APPLICATION NO.	FILING DATE	FIRST NAMED INVENTOR	ATTORNEY DOCKET NO.	CONFIRMATION NO.
10/500,430	06/28/2004	Kyung-Jin Kim	PISI 2 00008	9319
27885	7590	11/28/2005	EXAMINER	
FAY, SHARPE, FAGAN, MINNICH & MCKEE, LLP 1100 SUPERIOR AVENUE, SEVENTH FLOOR CLEVELAND, OH 44114			WIEKER, AMANDA FLYNN	
			ART UNIT	PAPER NUMBER
			3743

Office Action Summary	Application No. 10/500,430	Applicant(s) KIM, KYUNG-JIN	
	Examiner Amanda F. Wieker	Art Unit 3743

DETAILED ACTION

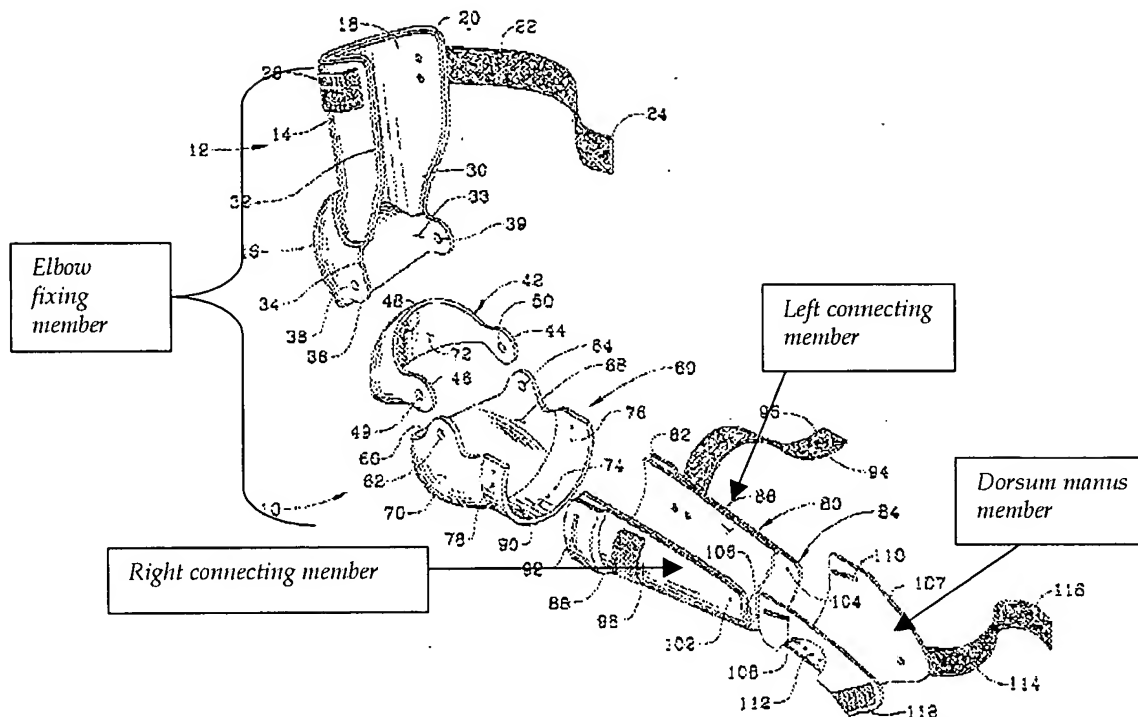
Rosenblatt discloses a combined splint and cast for immobilizing the injured body part due to fracture, ligament rupture, dislocation or the like, the combined splint and cast comprising (see below):

a hand fixing member including a dorsum manus member for wrapping the back of the hand and the wrist;

a connecting member including right and left connecting members which form a pair for wrapping the region from the wrist to below the elbow; and

an elbow fixing member for immobilizing the region from the elbow to the middle portion of the humerus, wherein the hand fixing member, the connecting member and the elbow fixing members are used separately or cooperatively by being fastened with bolts (locking screws). Rosenblatt does not specify that the hand fixing member include a palm member.
